Access Compliance Report

Public Rights-of-Way

(Curb Ramps)

Intersection ID: 47817	Main Street: DUSKY_PINE_DR	Cross Street: ROCKMOOR_RIDGE_RD	Location: NE
ADA ID: 5822E9727C2A	Ramp Type: PerpDiag	Initial Pass/Fail: Fail	Overall Compliance: No
Severity Score: 21.25			
Codes/Mitigation Info/Possible Solution		Field Measurements/Component Compliance

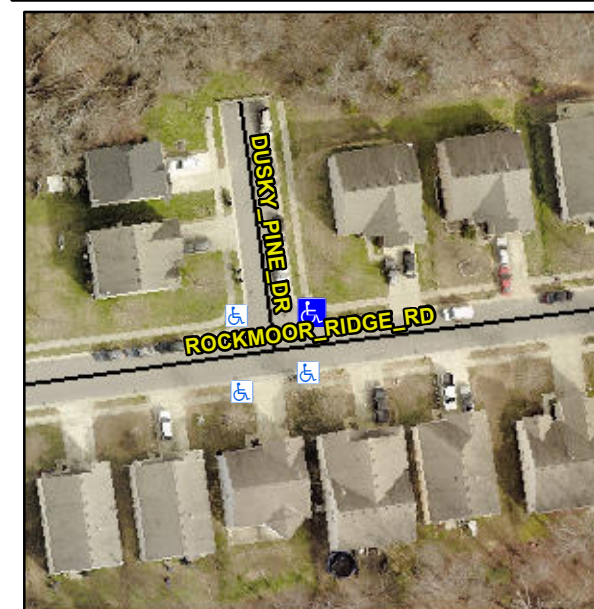
Not Found, R304.5.1, R304.2.2

Compliance	Description	Data	Compliance	Description	Data
N/A	Ramp Length (in)	46.0	No	Ramp Slope (%)	11.5
No	Ramp Width (in)	47.5	Yes	Ramp XSlope (%)	0.4
N/A	Flare Type LT	N/A	N/A	Flare Type RT	N/A
N/A	Flare Slope LT (%)	N/A	N/A	Flare Slope RT (%)	N/A
N/A	Flare Traversable LT?	N/A	N/A	Flare Traversable RT?	N/A
N/A	Landing Length (in)	N/A	N/A	DWS Provided?	N/A
N/A	Landing Width (in)	N/A	N/A	DWS Contrast?	N/A
N/A	Landing Slope (%)	N/A	N/A	DWS Length (in)	N/A
N/A	Landing X Slope (%)	N/A	N/A	DWS Full Width?	N/A
N/A	Landing Curb? (Y/N)	N/A	N/A	DWS Offset (in)	N/A
N/A	Shared Landing?	N/A			
N/A	Gutter Ponding?	N/A	N/A	Gutter Slope (%)	N/A
N/A	Gutter Lip Ht (in)	N/A	N/A	Gutter X Slope (%)	N/A
N/A	Painted X Walk1?	No	N/A	Painted X Walk2?	No
	X Walk 1 Direction	To W		X Walk 2 Direction	To S
N/A	X Walk 1 Width (in)	N/A	N/A	X Walk 2 Width (in)	N/A
	X Walk 1 Slope (%)	2.1		X Walk 2 Slope (%)	1.2
	X Walk 1 X Slope (%)	2.1		X Walk 2 X Slope (%)	1.9

Remove & Replace Curb Ramp With Two New Directional Ramps or Equivalent.
